In the Drawings

Remarks

This is in response to the Office Action mailed April 7, 2005. The amendments are proper, do not introduce new matter, more particularly set forth and distinctly claim the subject matter regarded as the invention by the Applicant, and are not narrowing in view of a prior art rejection.

FIG. 4

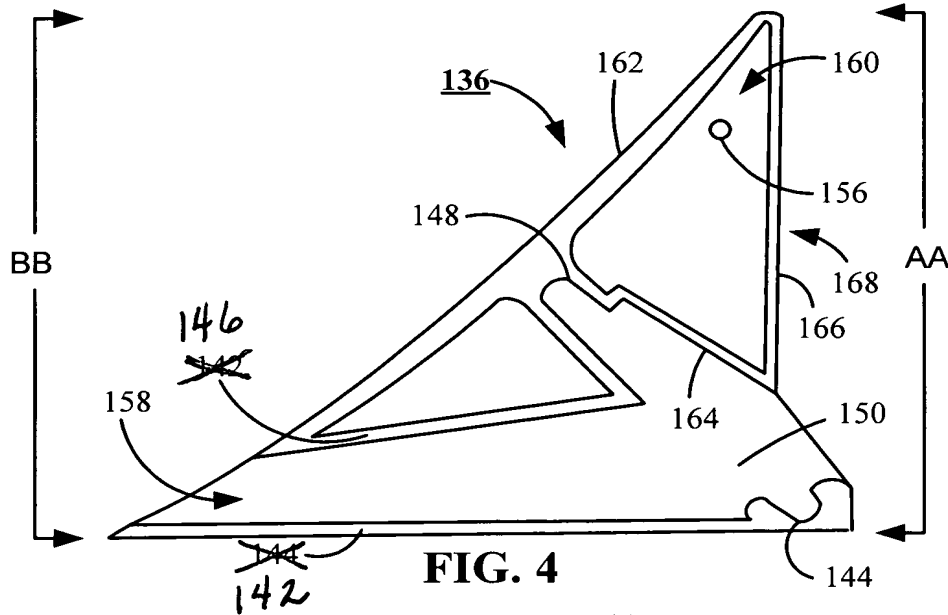
The attached sheet of drawings includes changes to FIG. 4. This sheet, which includes FIGS. 4 and 5, replaces the original sheet including FIGS. 4 and 5. In FIG. 4 numeral 146 replaces numeral 142 and numeral 142 replaces numeral 144.
